TOWN OF KILLINGLY

TOWN OF KILLINGLY PERMANENT BUILDING COMMISSION SPECIAL MEETING

- 3. Adoption of Minutes: March 26, 2024 special meeting
- 4. Unfinished Business:
 - a. KMS Renovate As New with Addition Project
 - 1. Downes project status update

Prime Contract Potential Change Order #058: CE #058 - Provide power to AC-2 units in corridors

C - 1 0 4

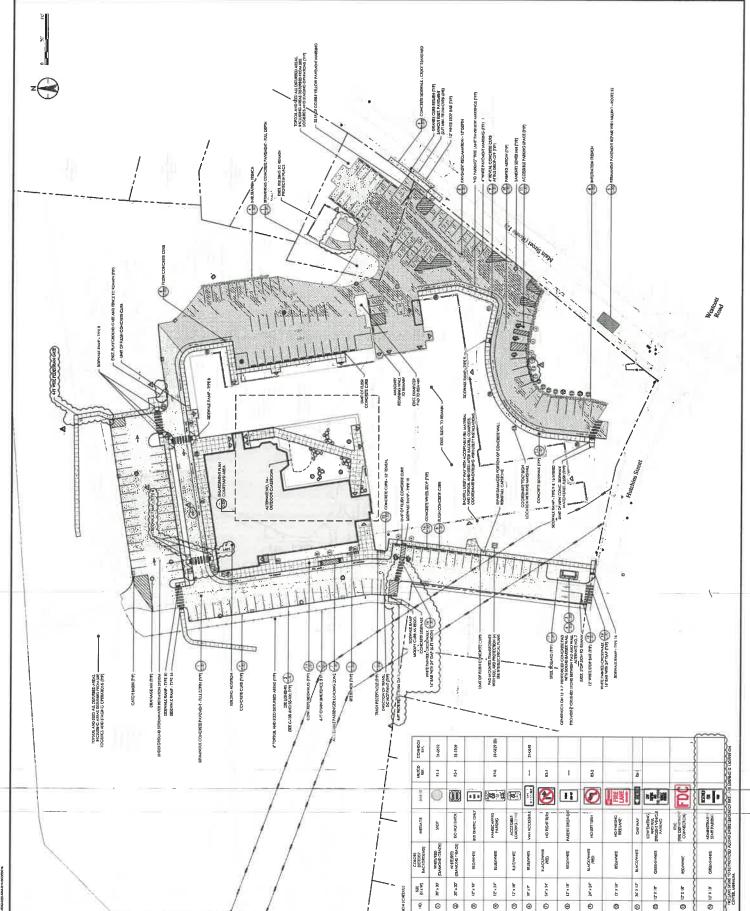
Provide a proposal for the following Site related changes requested by the Owner:

Description: PR #14 Site Changes - New pavement at the east existing out building, added signs at staff parking,

added line striping for crosswalks/hatching, added two gates in existing and new fencing, added
